RE: Uranerz Energy Corporation, Nichols Ranch ISR Project, NRC License SUA-1597, Docket No. 40-9067 (TAC J00726), Jane Dough Unit License Amendment Request

INDEX SHEET FOR MINE PERMIT AMENDMENTS OR REVISIONS

MINE COMPANY NAME: Uranerz Energy Corporation
MINE NAME: Nichols Ranch ISR Project

FIGURE 3-9A
HEADER HOUSE DETAILS
(TYPICAL)

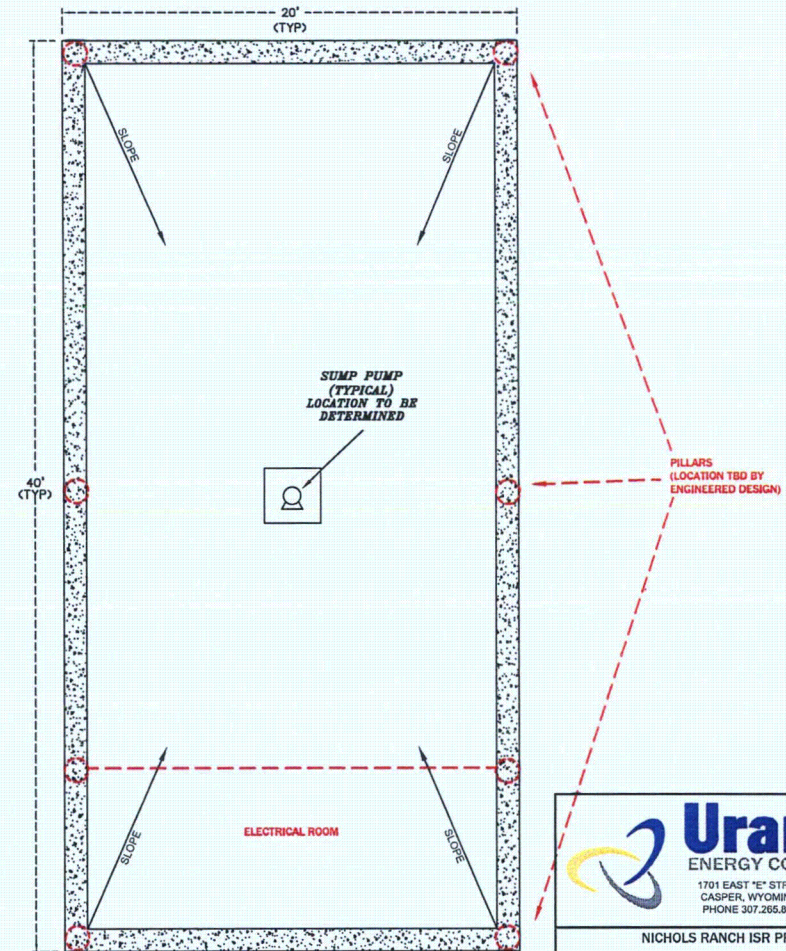
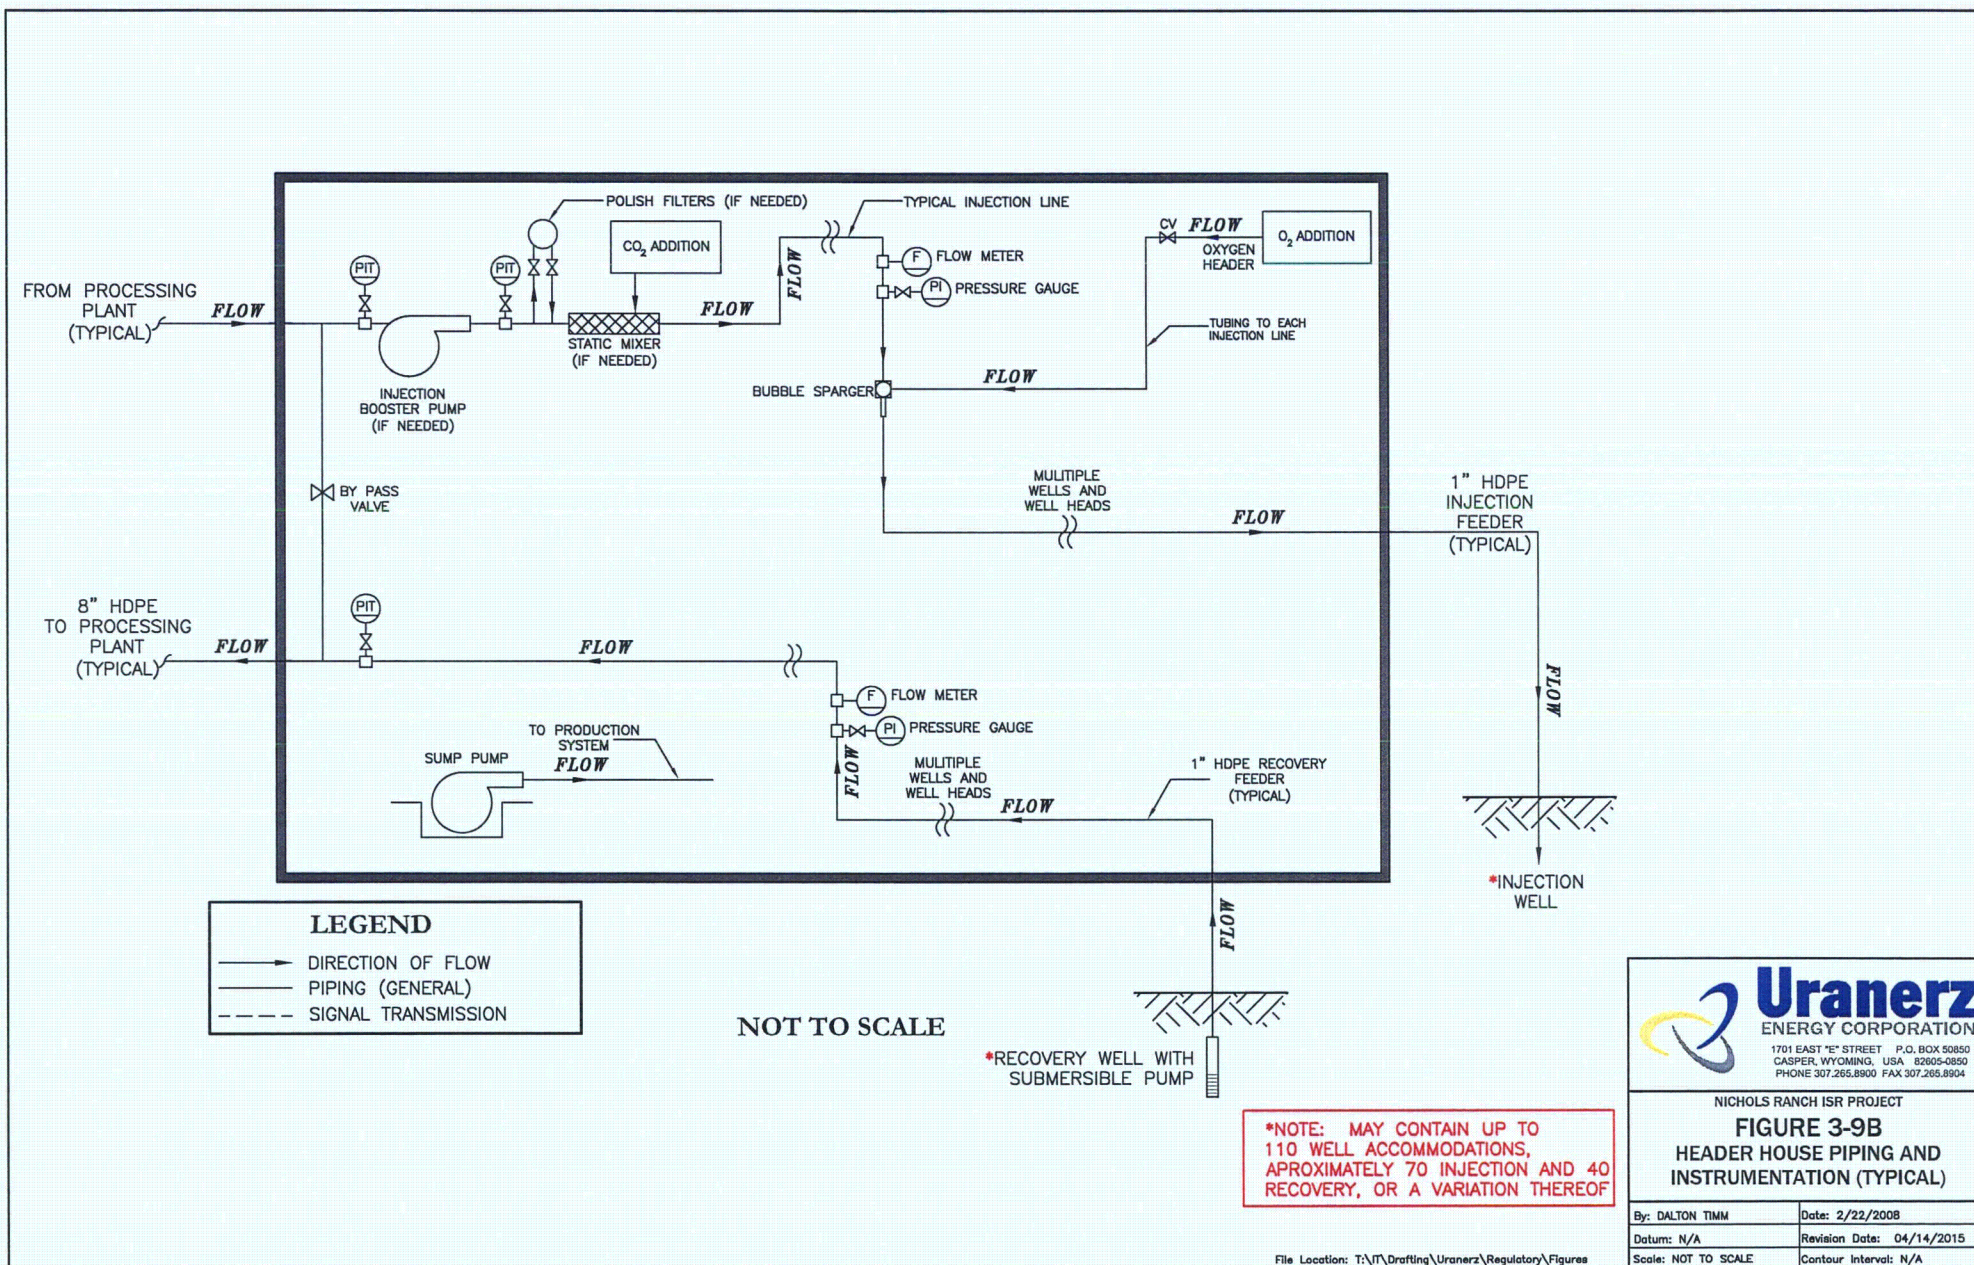
Depending on the oxidation requirement of the formation, the injection wells may be equipped with oxygen spargers so that each well can be controlled as to the amount of oxygen concentration it receives, or a header house oxygen manifold distributor will be installed. Header houses are small buildings that contain the manifolds with valves, piping, and instrumentation for injection and recovery wells. Each header house will contain approximately 110 well accommodations, but may contain more or less. **The typical header house design is shown in Figure 3-9A Header House Details (see map pocket), and the details of the piping and instrumentation for the header house is shown in Figure 3-9B Header House Piping and Instrumentation (see map pocket).**

The header houses will be metal buildings. **The dimensions for the header houses will be approximately 40 feet by 20 feet, but may be more or less. The terrain and logistics in the wellfield will determine which engineered foundation (e.g. pad, pillar, or basement) the header house will be built on. The foundations will be constructed of durable materials that meet engineering requirements or other suitable materials with sealed penetrations (as needed) to provide containment.** The foundation will have grating which will allow access to the sub floor containing valves and hose runs. **The floor will curb and/or slope to a sump with an automatic level control pump. The sump will pipe to the recovery system and will include check valves. In header houses with basements the basement will contain the hose runs and injection and recovery lines. The header house may be designed to contain the electrical equipment in the same room with the piping or the electrical room may be attached to the main header house building and placed on concrete pillars that are buried underground for structural support.**

Figure 3-12

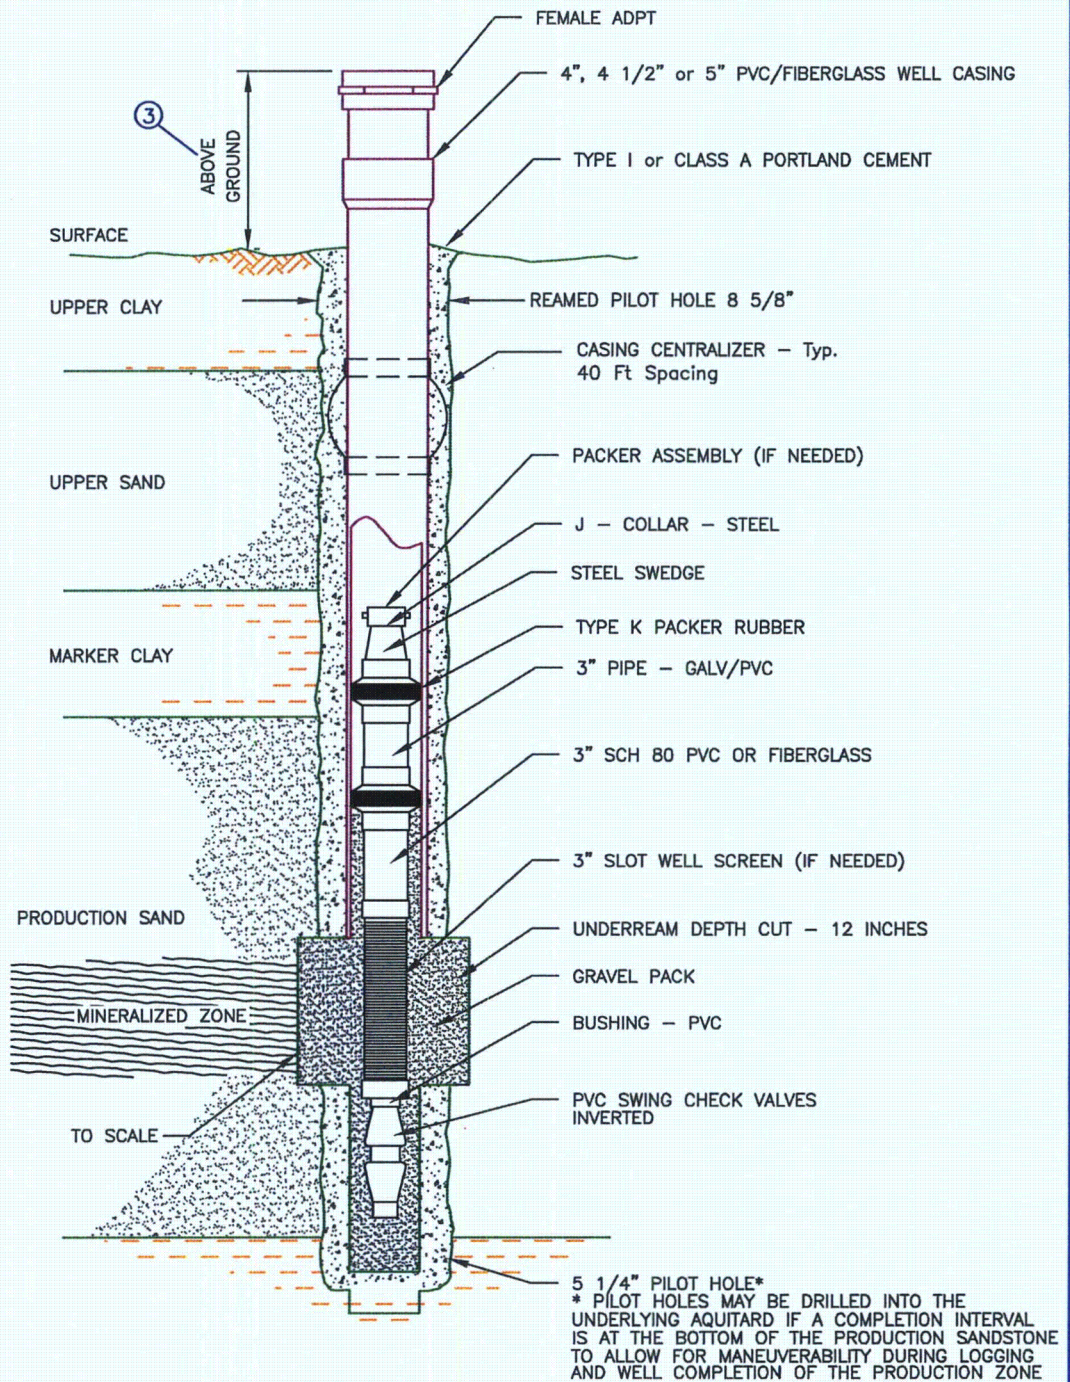
Drawn: BW		Checked: SK	
Date: 01/05/2014			
Revision	Description		
3/11/14	Add Jane Dough		
05/11/15	Add Jane Dough		
G:\Projects\198305\IDMXD\2015_Fig_3.11_PredictedSchedule.mxd

FIGURE 5-1 URANERZ ORGANIZATION

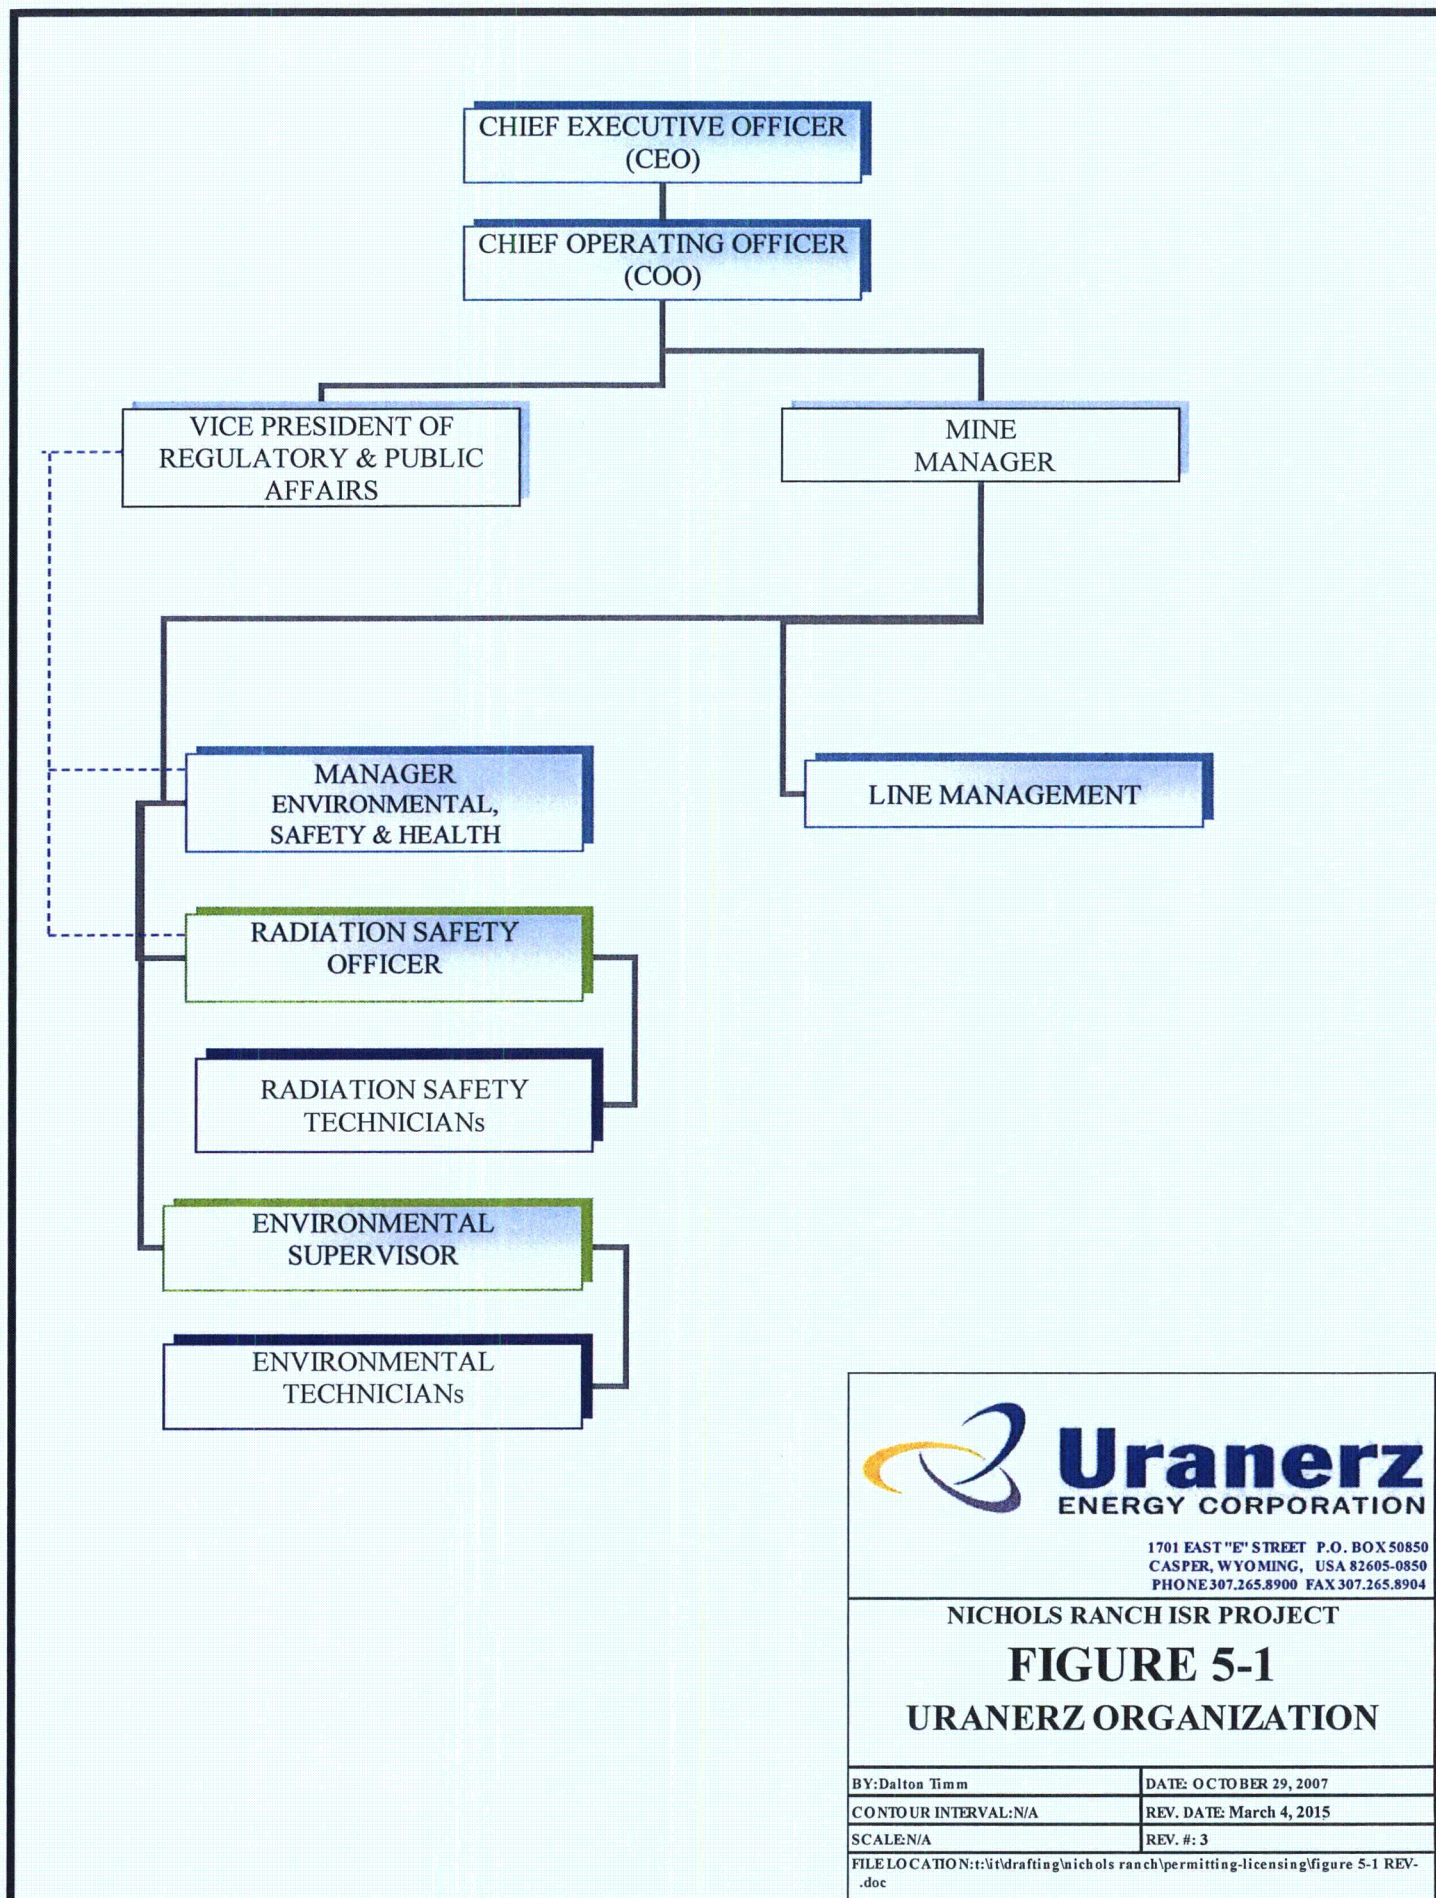
Jane Dough Amendment Volume I	Mine Plan: Chapter 3, Section 3.4.5, pg TR-182	Mine Plan: Chapter 3, Section 3.4.5, pg TR-182	The pages were updated per a SERP completed at site with pages changes made in the existing license application. These items have also been reviewed and approved by WDEQ-LQD in the current Permit to Mine No. 778.
Jane Dough Amendment Volume I	Mine Plan: Chapter 3, Section 3.4.6, Pgs. TR-184 and TR-185	Mine Plan: Chapter 3, Section 3.4.6, Pgs. TR-184 and TR-185	The two pages were revised in response to LQD comments and to keep the documents consistent is being revised herein.
Jane Dough Amendment Volume I	Mine Plan: Chapter 3, Figures 3-9A through 3-9C, 3-12, 3-13	Mine Plan: Chapter 3, Figures 3-9A, 3-9B, 3-12, 3-13	The figures have been revised to reflect changes in the text.
Jane Dough Amendment Volume I	Mine Plan: Chapter 5, Section 5.1.1, Pgs TR-201 through TR-206, Figure 5-1	Mine Plan: Chapter 5, Section 5.1.1, Pgs TR-201 through TR-206, Figure 5-1	The pages and figure were updated via SERP's and page changes reflect the existing license application
